<input type="checkbox"/> Minor – Preliminary/Final Plat (Form S2)	<input type="checkbox"/> Sidewalk Waiver (Form V2)	
SITE PLANS	<input type="checkbox"/> Waiver to IDO (Form V2)	APPEAL
<input type="checkbox"/> DRB Site Plan (Form P2)	<input type="checkbox"/> Waiver to DPM (Form V2)	<input type="checkbox"/> Decision of DRB (Form A)
BRIEF DESCRIPTION OF REQUEST		
DRB sign-off for EPC approved Site Plan.

**CARE CENTER (MORTUARY & CREMATORIUM)
3300 VASSAR DRIVE NE
SITE PLAN**

Re: 3300 Vassar Dr. NE (SI-2021-01685, RZ-2021-00045) Final Site Plan Sign-off

The purpose of this letter is to transmit the Site Plan that was approved by the Environmental Planning Commission (EPC) on November 18, 2021. The EPC placed the following conditions of approval. The response to each of the conditions are shown below.

SCALE:
SITE PLAN

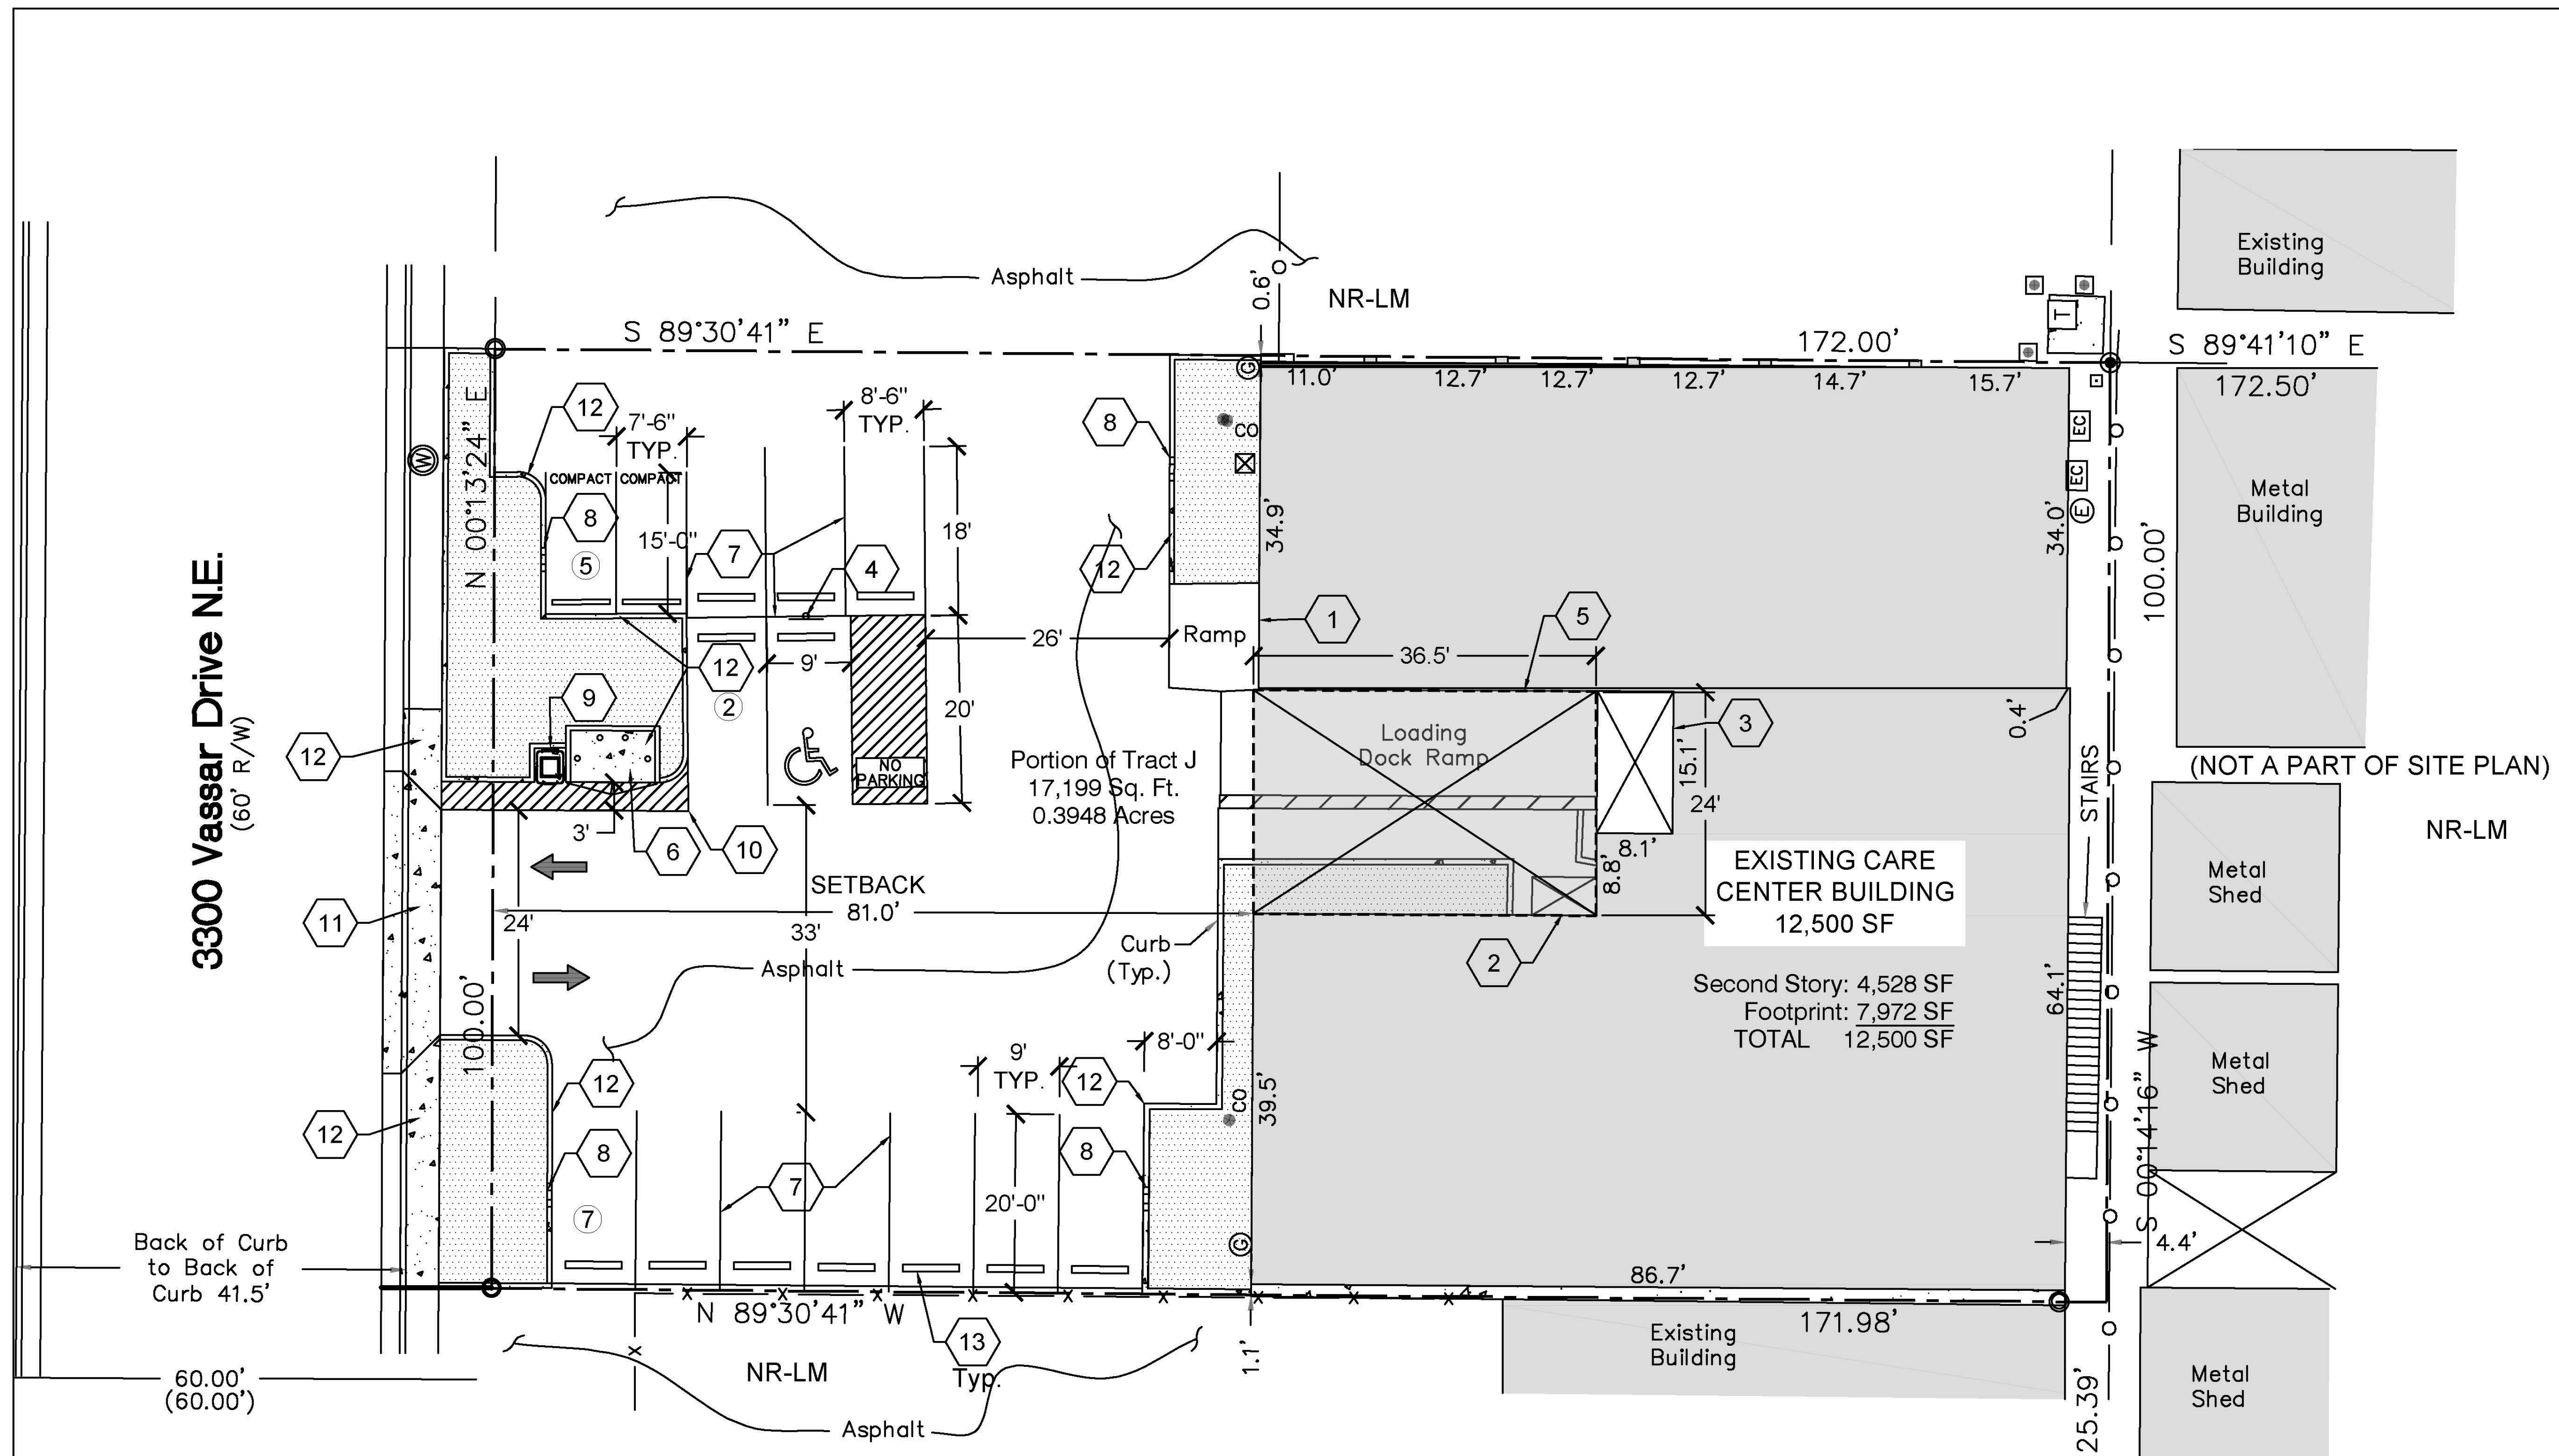
4. Pursuant to IDO section 2-5(E)(3), the applicant shall provide a Site Plan EPC that specifies uses, site standards, and development standards for staff review. This includes the standards shown in IDO table 2-5-9. Applicant may use NR-LM as a base for setting standards for the proposed site plan (i.e., demonstrate where it meets NR-LM and where it varies, clearly on the site plan).

5. Dimensional Standards: The site plan shall clearly identify dimensional standards proposed, and how they vary or conform to the NR-LM standards, pursuant to IDO section 5-1(E)(2)(b) – NR-SU zone district.

6. Dimensional Standards: The site plan shall clearly dimension the building footprint.

7. Parking: The site plan shall clearly and correctly dimension parking lot aisleways.

15. Site Plan – Clean Up: The note regarding depressed landscaped areas shall be removed from sheet one of the site plan, it is only needed on the landscape plan.

16. Site Plan – Clean Up: The square footage calculations shall be shown per floor, i.e., total square footage for 1st floor and total square footage for 2nd floor.

17. Site Plan – Clean Up: The refuse enclosure shall incorporate at least 1 of the primary colors and materials of the existing building pursuant to IDO section 5-6(G)(3)(e).

18. Site Plan – Clean Up: The total square footage for the proposed porch cover shall be accurately shown on the site plan. Staff found that 44.2' x 23.9' is equal to 1,056.38 square feet, which is more than 1,000 square feet. The site plan shows the proposed porch at under 1,000 square feet.

19. Site Plan – Clean Up: The proposed porch cover shall be clearly dimensioned.

28. Solid Waste Management Conditions: A site plan to scale approved for access will be required by the Solid Waste Department.

30. Solid Waste Management Conditions: An apron to the trash enclosure will be required.

The Site Plan - Sheet 1 has been updated to add a Dimensional Standards table that reflects the applicable IDO Table 2-5-9 standards.

The Site Plan - Sheet 1 has been updated to add a Dimensional Standards table that reflects the applicable IDO Table 2-5-9 standards.

Additional building dimensions have been added to the Site Plan – Sheet 1.

Additional parking and aisleway dimensions have been added to the Site Plan – Sheet 1.

The Site Plan – Sheet 1 has been updated to remove this note from Sheet 1.

The building footprint and 2nd story square footage have been added to the Site Plan – Sheet 1.

The refuse enclosure will be painted white to match the existing building as shown on the standard detail “Refuse Enclosure Concrete Pad” on the Site Plan - Sheet 1.

The square footage of the porch cover has been updated to 876 SF based on the 36.5' x 24' dimension as shown on the Site Plan – Sheet 1.

The square footage of the porch cover has been updated to 876 SF based on the 36.5' x 24' dimension as shown on the Site Plan – Sheet 1.

A meeting was held on November 29, 2021, with Herman Gallegos from the Solid Waste Department. Site plan dimensions are included on the updated site plan in accordance with instructions provided by Mr. Gallegos.

A striped apron was added in front of the trash enclosure as required.

LANDSCAPE
PLAN

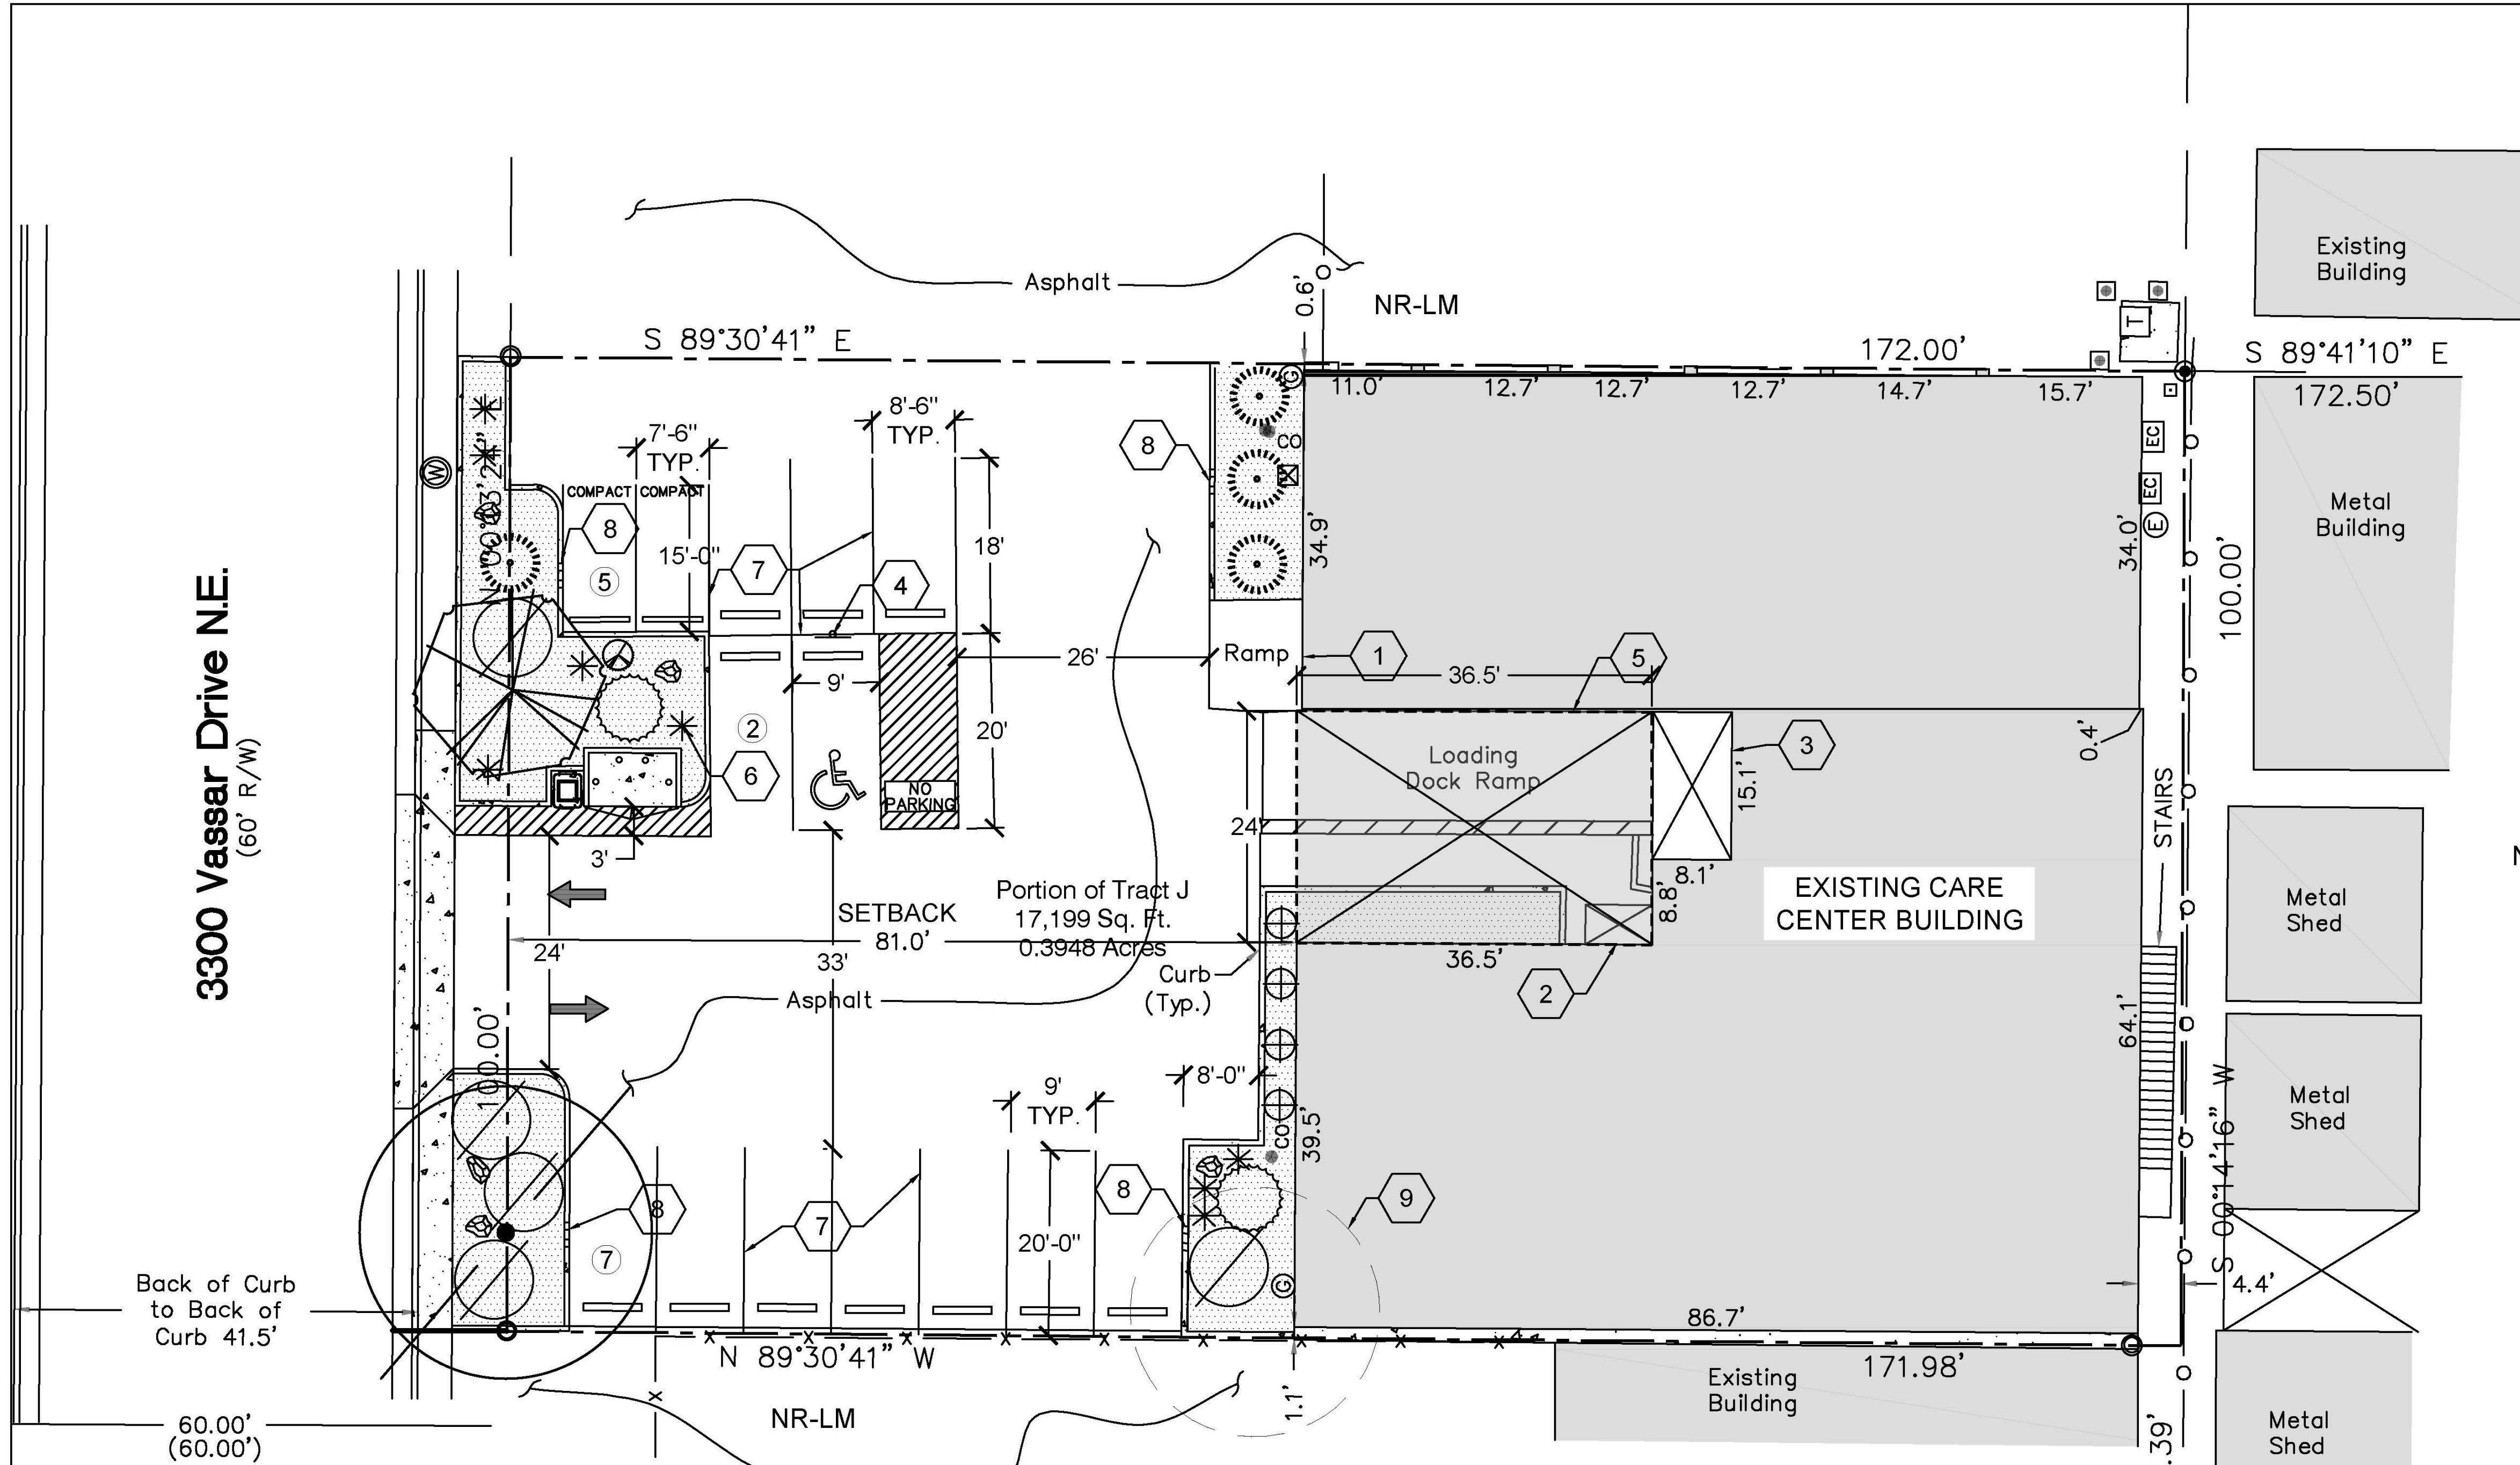
8. Landscaping - General: Landscape calculations shall be updated to reflect the accurate overall lot size.

9. Landscaping - General: The site plan shall show which IDO provision was used to determine the appropriate landscaped area, i.e., pursuant to IDO subsection 5-6(C)(2) the minimum landscaped area shall be 15% of the net lot area.

10. Landscaping - General: Calculations shall demonstrate how the net lot size was determined.

11. Landscaping - General: A note shall be added stating that requirements under IDO section 5-6(C)(10) – Planting Near Utilities shall be met.

12. Landscaping - General: The note regarding depressed areas shall add the relevant IDO citation, IDO section 5-6(C)(13) – Stormwater Management.

13. Landscaping - General: The plant list shall be updated to clarify that only female Buffalo Juniper shall be used.

14. Landscaping - General: No turf is shown on the landscape plan, language discussing the amount of watering for turf shall be removed, or the turf shall be clearly shown on the landscape plan.

31. Solid Waste Management Conditions: Landscape plan – The proposed Urbanite Ash (tree) will have to be relocated. It cannot overhang the trash enclosure.

Updated calculations were added to reflect the overall lot size and clarified on the Landscape Plan – Sheet 2.

The Landscape Plan – Sheet 2 has been revised to update and clarify the calculations.

The Landscape Plan – Sheet 2 has been revised to update and clarify the calculations.

This note has been added on the Landscape Plan - Sheet 2 in the lower lefthand corner.

This note has been added on the Landscape Plan - Sheet 2 in the lower lefthand corner.

The plant list was updated on the Landscape Plan – Sheet 2 to indicate “Female Only” for the Buffalo Juniper.

The Landscape Plan – Sheet 2 has been updated to remove any reference of turf.

The Urbanite Ash tree was removed from and replaced with a Chinese Pistache and relocated on the site plan so that it would not overhang the trash enclosure.
